**Treatment Plan for Cultural and Historic
Resources at Aloha Stadium Station
Honolulu Rail Transit Project**

Final

November 2014

Honolulu Rail Transit Project Treatment Plan for Cultural and Historic Resources at Aloha Stadium Station

Modification of Aloha Stadium Station Design to Avoid Station Entrance on PHNHL

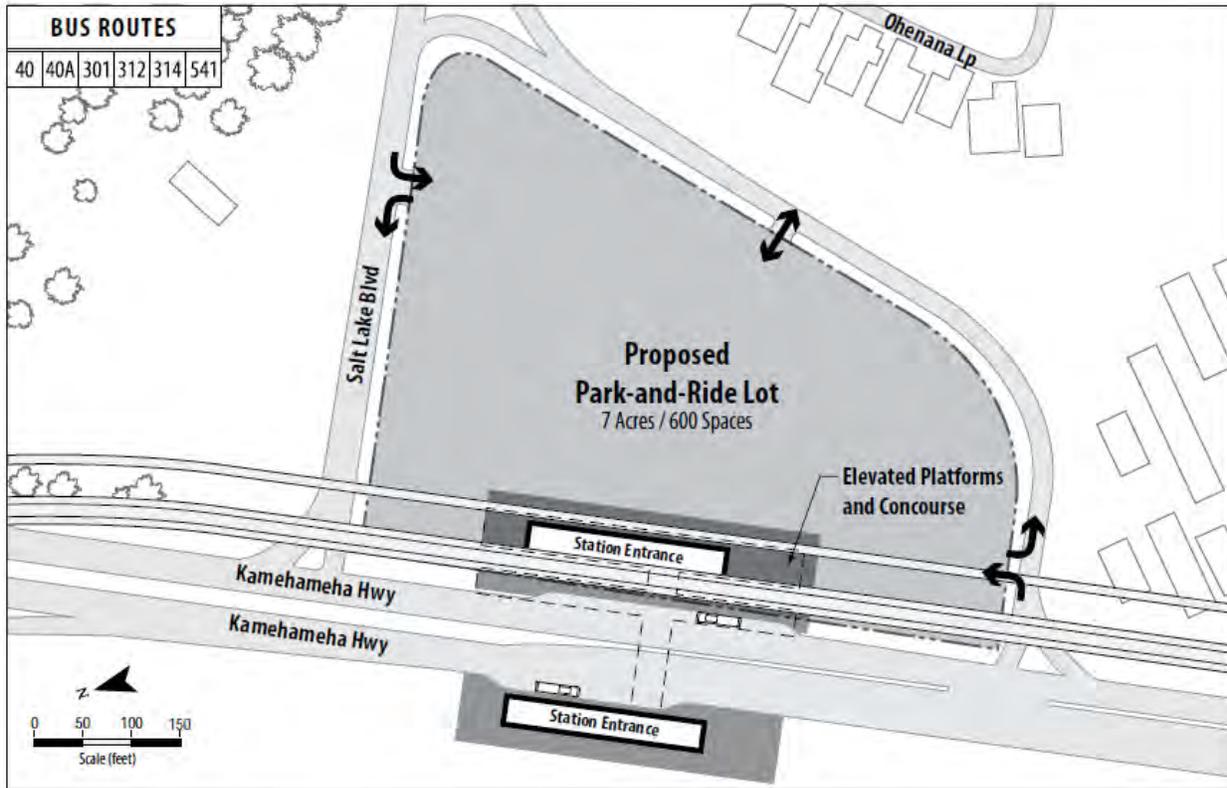
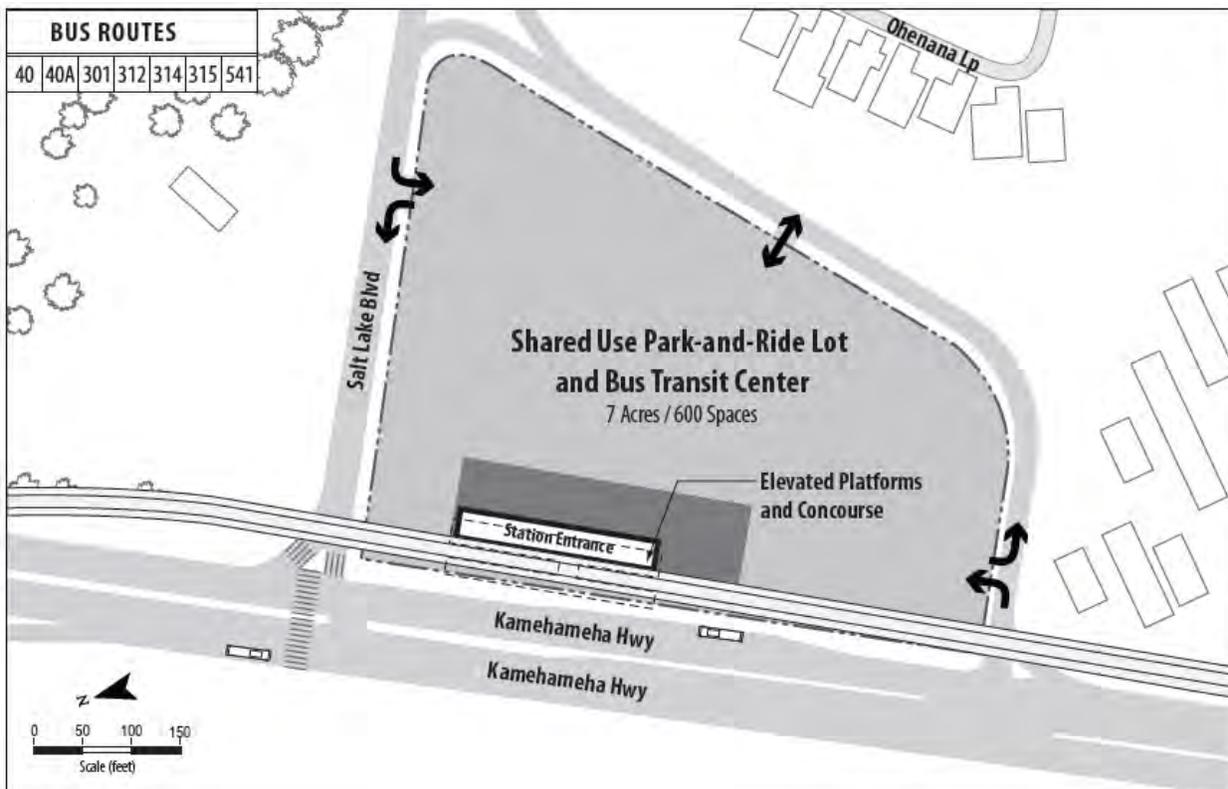
This attachment shows the change in the design of the Station during the EIS process to avoid having any station components within the boundary of the Pearl Harbor National Historic Landmark. The change also resulted in the removal of a sky bridge over Kamehameha Highway and the reduction of the Station's area by 3,500 to 4,000 square feet.

Initial Siting of Aloha Stadium Station with Station Entrance on Makai side of Kamehameha Highway within Pearl Harbor National Historic Landmark

Current Siting of Aloha Stadium Station with no Station Components with Boundary of Pearl Harbor National Historic Landmark
